PRELIMINARY/FINAL DRAINAGE REPORT

JUDGE ORR ROAD RV PARK & STORAGE DEVELOPMENT

**ADP Project No.160301
June 14, 2019**

PCD Project #PPR-16-040

Figure 9-35. Expansion factor for circular conduits

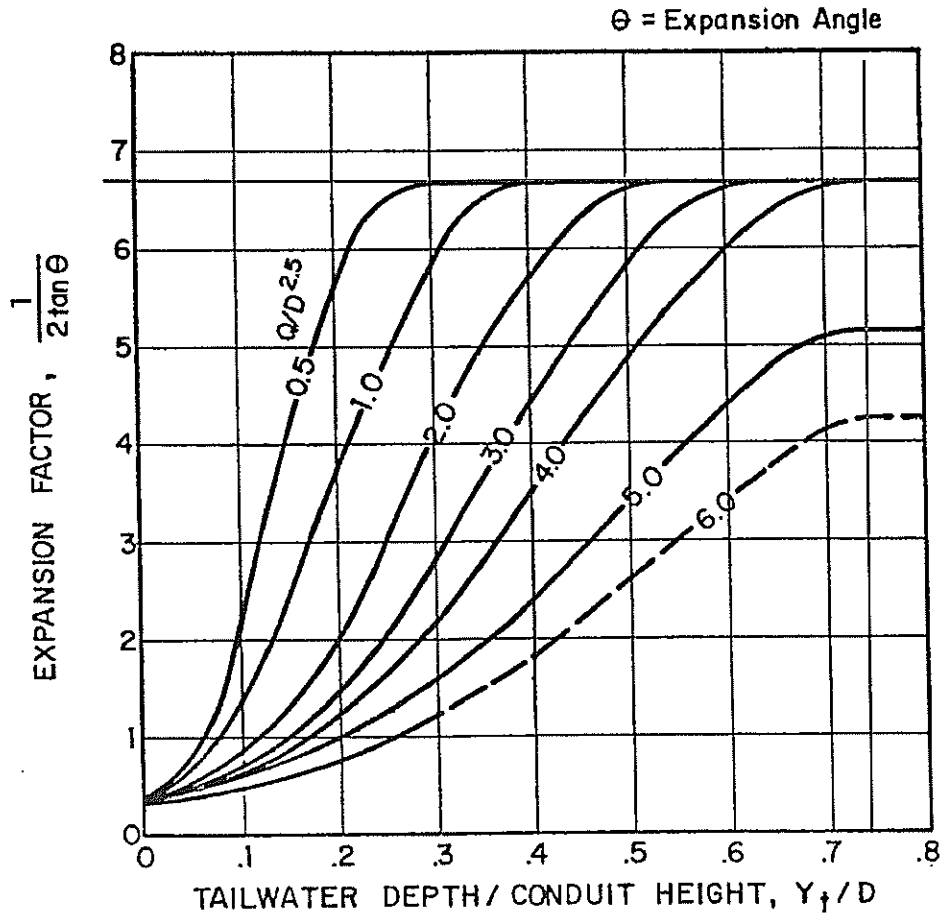
Outlet protection calculation is incomplete. Show the variables used. Additionally, this only provides the riprap sizing, but not the required length for the protection. Use the UD-Culvert worksheet. The length of outlet protection appears to be inadequate.

Unresolved. Variables used for Q, D, Yt, D is not provided. Update calculation. This chart is still the same chart from the previous design when the future pond drained into Pond 2 (Pond-in-a-series). Values are unlikely to remain the same. The current drainage has since been revised to discharge this offsite flow separate form Pond 2 at the same spillway location. Riprap sizing must account for the combined flow.

DETENTION BASIN STAGE-STORAGE TABLE BUILDER

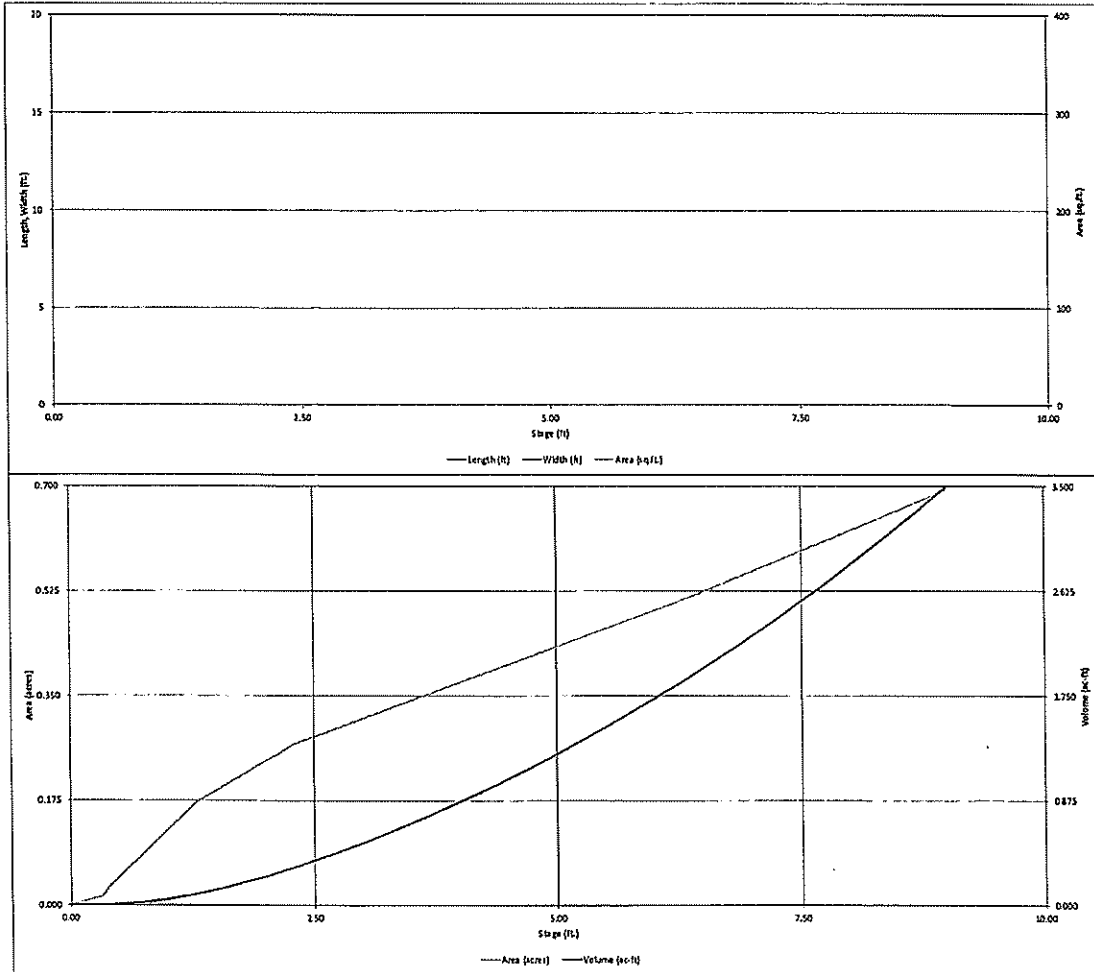
Update the Basin ID to match the Detention Basin Stage-Storage Table Builder worksheet.

Detention Basin Outlet Structure Design

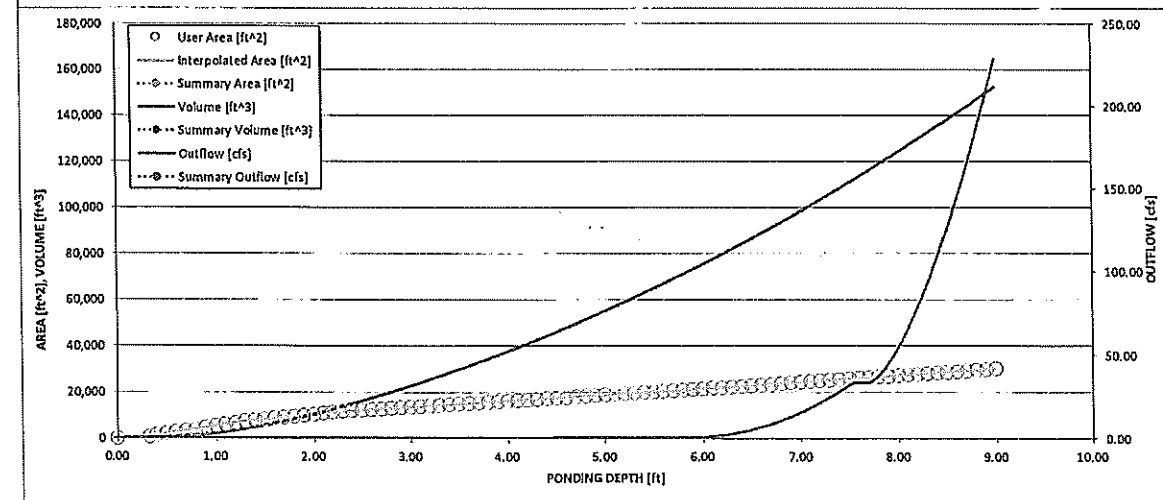
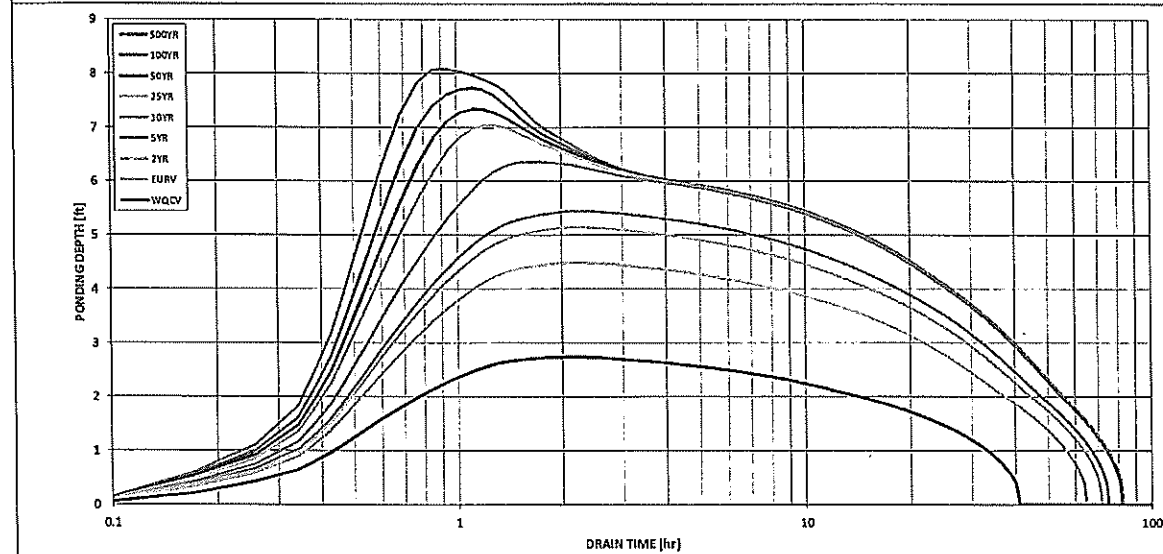
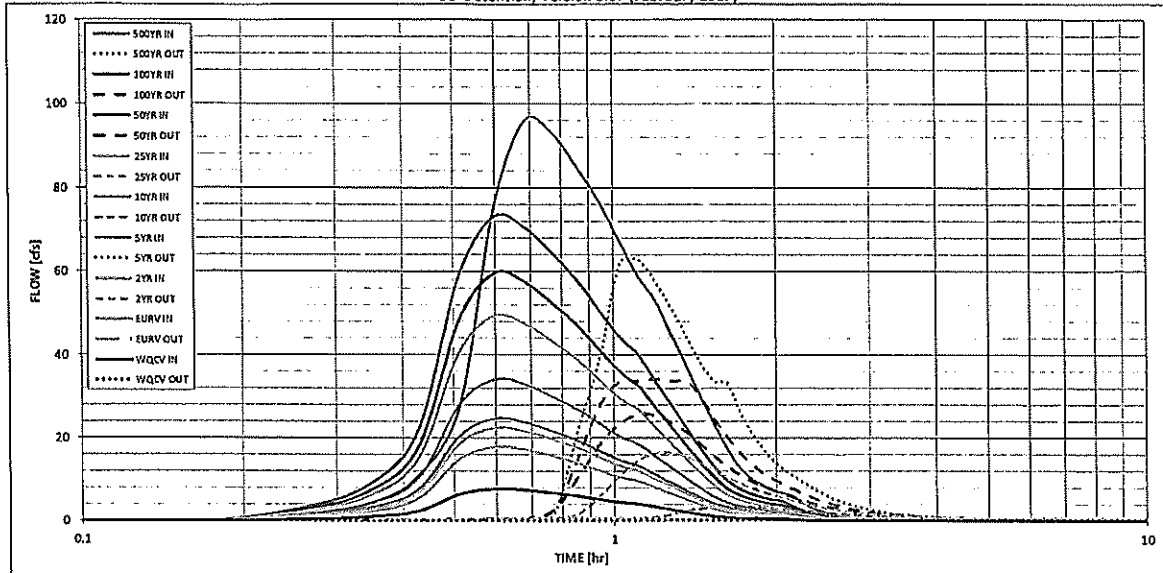
2. Revise design so the 100yr goes through the outlet pipe.

Unresolved. The 100yr is still discharging over the emergency spillway. Revise outlet structure design to provide capacity for the 100yr release rate.
